Contract #: 04-0120F4Cty: SF/ALA Rte: 80 PM: 13.2/13.9File #: 69.25B**QUALITY ASSURANCE -- NON-CONFORMANCE REPORT****Location:** Changxing Island, Shanghai, P.R. China**Report No:** NCR-000728**Prime Contractor:** American Bridge/Fluor Enterprises, a JV**Date:** 03-May-2010**Submitting Contractor:** Zhenhua Port Machinery Company, Ltd (ZPMC), Changxing Island**NCR #:** ZPMC-0691**Type of problem:**

Reference Description: ZPMC welded some welds in Segment 12AE & 12AW U-Rib Deck Panel without following the approved WPS and shop drawings

Subject: NCR No. ZPMC-0691

Contract #: 04-0120F4Cty: SF/ALA Rte: 80 PM: 13.2/13.9File #: xx.25A**QUALITY ASSURANCE -- NON-CONFORMANCE RESOLUTION****Location:** Changxing Island, Shanghai, P.R. China**Report No:** NCS-000819**Prime Contractor:** American Bridge/Fluor Enterprises, a JV**Date:** 12-Oct-2010**Submitting Contractor:** Zhenhua Port Machinery Company, Ltd (ZPMC), Changxing Island **NCR #:** ZPMC-0691**Type of problem:**

MT-NCR-12W-001 (2 of 3)

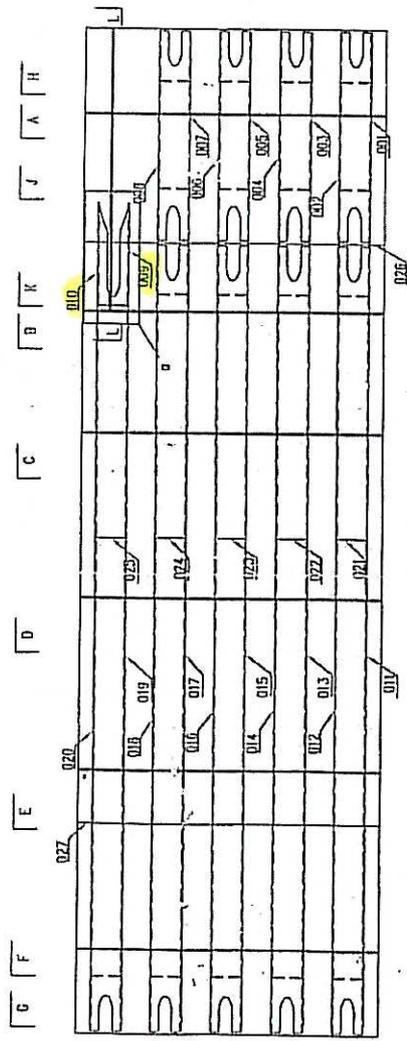
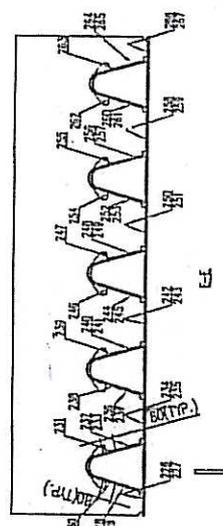
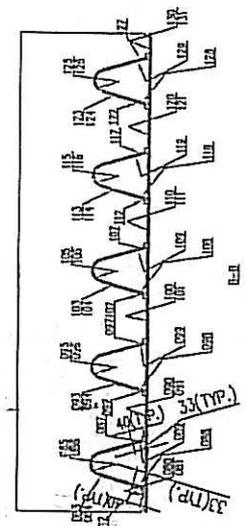
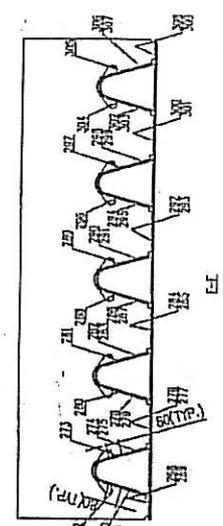
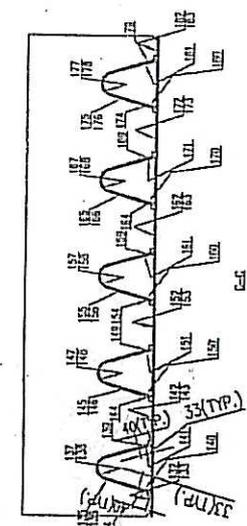
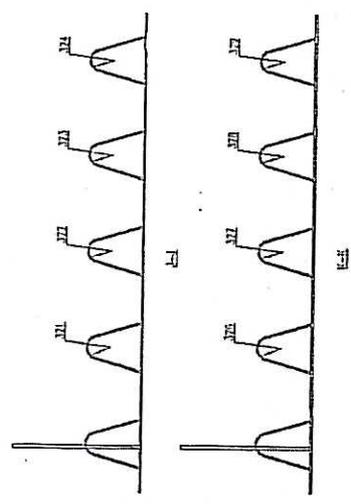
-ZPMC personnel reported the use of WPS-B-T-2342-U5 (GMAW) for the root pass and WPS-B-T-2232-Tc-U4b-F, (FCAW) for the cover pass for the welds in Segment 12AW:

Weld ID: DP3045-001-001 & 002 (RS3031D to PL3108B)

Weld ID: DP3043-001-009 & 010 (RS3031E to PL3106B)

Reference Resolution: ABFJV has performed depth of penetration UT testing to show that the weld has achieved a depth of penetration of seventy percent or higher in both welds as well as MT of the cover pass.

The welds were welded with the approved WPS with subsequent NDT verifications. This NCR is closed.
